**Motion and Title:** Staff recommends motion to approve: Change Order No. 6 to the Contract with Widell, Inc. (R2005-1893) for the Northern Region Utility Site increasing the contract price by \$13,516.81 and providing a 118-day time extension.

CHANGE ORDER NO.: 6 (Six)

BRP UTILITY SITE  
PROJECT NO. : WUD 05-018  
DISTRICT = 6  
Contract No. R2005-1893  
CHANGE ORDER NO.: 6 (Six)

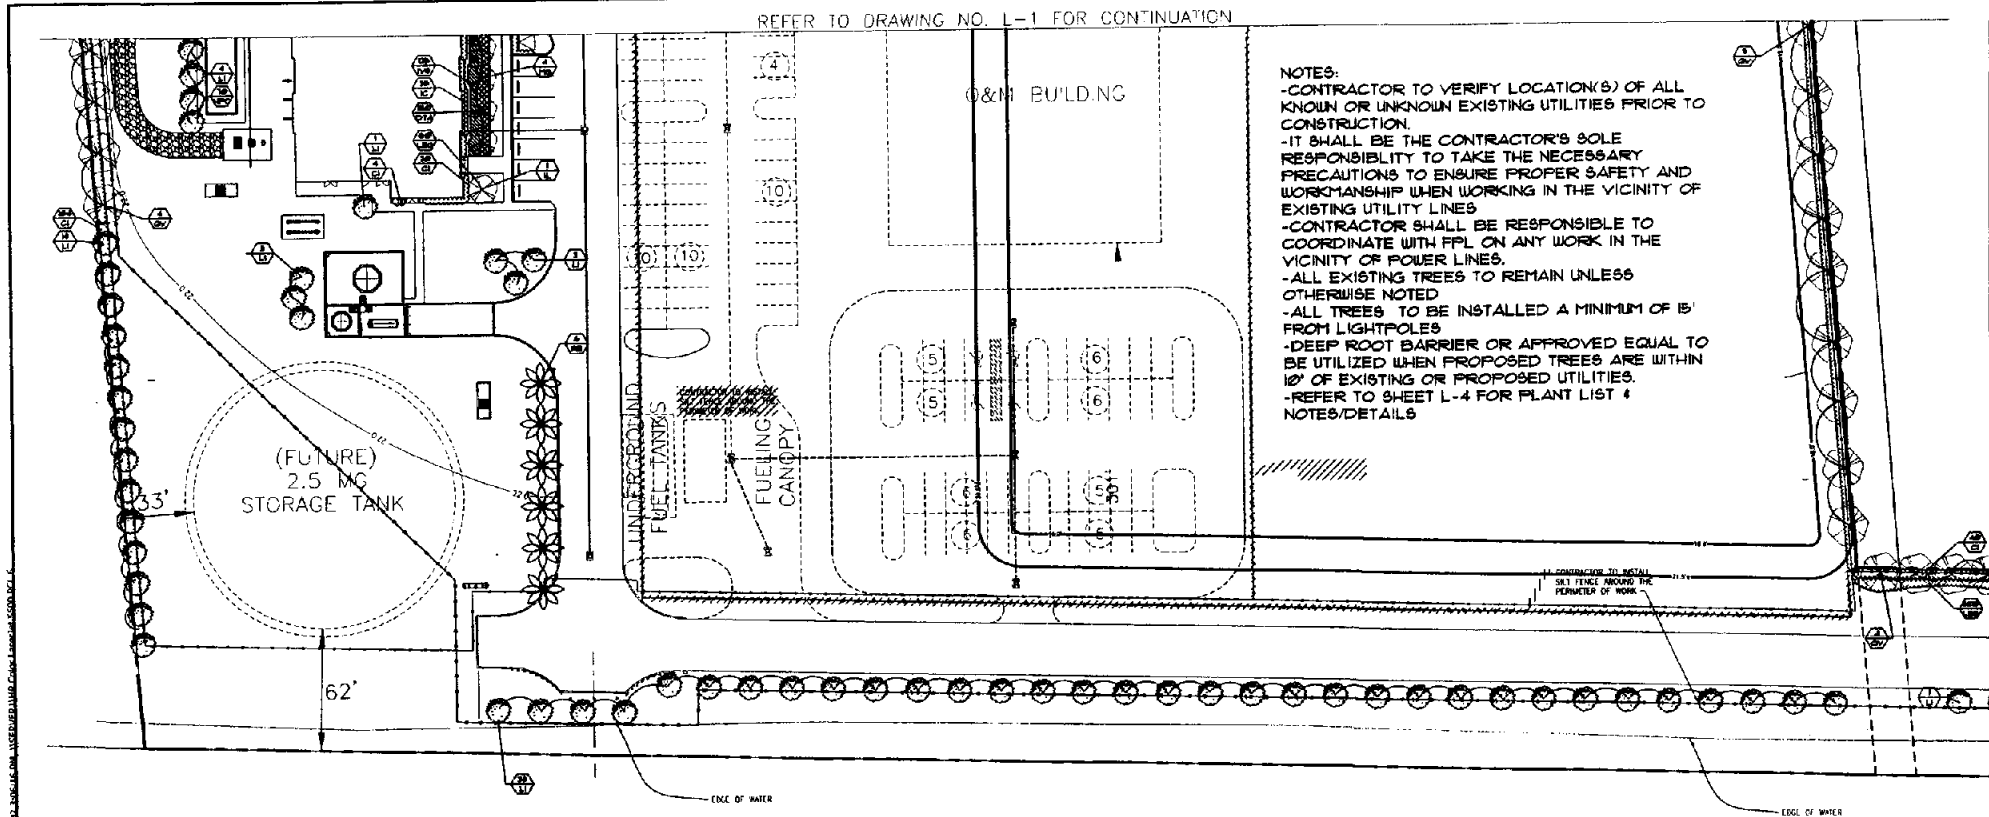
**TO:** Hal Myrah  
**FROM:** Rene L. Mathews, P.E.  
**DATE:** December 4, 2006  
**SUBJECT:** Request for Proposal #10  
Revised Landscaping and Irrigation

Please provide a detailed quote to revise the site landscaping and irrigation as shown on the attached revised drawings. The following changes have been made:

- ◆ Sheet L-1:
  - Changed size of green buttonwood to 3 gal.
  - Eliminated the Sabal Palms along fence line
  - Reduced size of oak trees around storage tank and fence line from 16 ft. Oa to 14 ft. Oa.
  - Changed material around pump building.
- ◆ Sheet L-2:
  - Revised landscape to reflect new road alignment.
  - Changed material around pump station.
  - Eliminated Pines at front entrance, substituted Royal Palms.
- ◆ Sheet L-3:
  - Revised landscape to reflect new road alignment.
  - Eliminated landscape material along roadway.
- ◆ Sheet L-4:
  - Revised plant list to reflect changes on drawings.
- ◆ Sheet IRR-2:
  - Revised irrigation to reflect new road alignment.
  - Changed head layout along roadway.

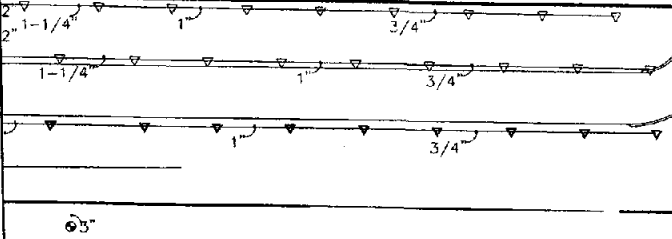
- ◆ Sheet Irr-3::
  - Revised landscape to reflect new road alignment.
  - Changed head layout along roadway
  - Eliminated additional heads along roadway.
